UNITED STATES PATENT AND TRADEMARK OFFICE

APPLICATION NO.	FILING DATE	FIRST NAMED INVENTOR	ATTORNEY DOCKET NO.	CONFIRMATION NO.
10/707,874	01/20/2004	Kent Kuohua Chang	9945-US-PA-1	1873

Office Action Summary	Application No.		Applicant(s)	
	10/707,874		CHANG, KENT KUOHUA	
	Examiner		Art Unit	
	Fernando L. Toledo		2823

DETAILED ACTION

Figure 7 has been modified to underscore that it shows the at least 4 conductive blocks.

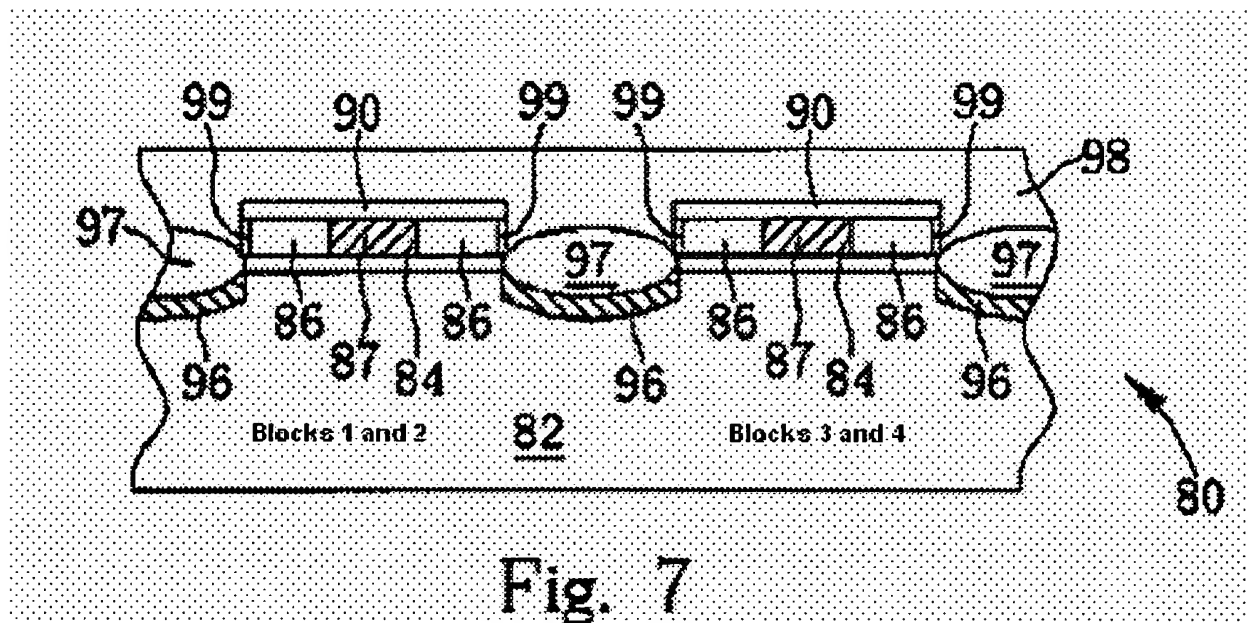
16. Applicant contests that Chang does not show more than two conductive blocks.

Examiner respectfully submits that Figure 7 of Chang shows at least 4 conductive blocks.
